re: Grading and Site Servicing Plan Review
Proposed Self Storage Development
75 Michael Cowpland Drive – Ottawa, Ontario

file: PG3798-MEMO.02 Revision 4

Site Servicing Plan Review

Figure 1 - Proposed Thickened Edge Slab Foundation Insulation Detail

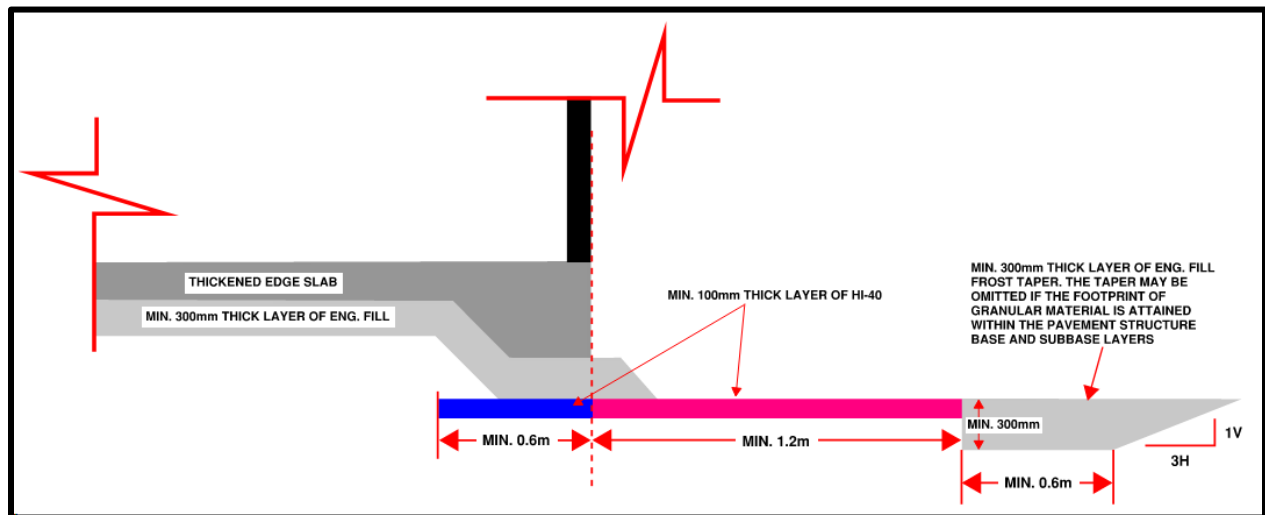
Upon discussions with the design team, the proposed thickened edge slabs are now proposed to be placed on vertical, concrete in-filled trenches where adjacent service pipes are proposed with the lateral support zone of the proposed structures. These trenches would lower the lateral support zone of the slabs below the service trenches ensuring that the proposed buildings are protected should future excavation be required for the proposed services for maintenance purposes.

Due to the anticipated depth and proximity of the proposed service pipes to the proposed thickened edge slab footprints, it is expected the lateral support zones for the proposed structures will be negatively impacted by the service installation works. Further, future maintenance that could be considered throughout the proposed service alignments would require trenches that would impact the proposed buildings lateral support zones. Based on this, it is recommended to lower the lateral support zones for thickened edge footings located adjacent to impacting service alignments. This may be accomplished by sub-excavating a near-vertical trench located directly below the overlying footing footprint and in-filled with minimum 17 MPa lean-concrete.

It is recommended the near-vertical trenches extend a minimum of 150 mm horizontally beyond the overlying footing footprint. Based on our review, the lean-concrete trench detail has been incorporated satisfactorily into the above-noted site servicing plans. The recommended perimeter thickened-edge slab foundation insulation detail is depicted below for the proposed storage structures and has been incorporated satisfactorily in the above-noted site servicing plans. The placement of the lean-concrete trench and rigid insulation should be reviewed and approved by Paterson personnel at the time of construction.
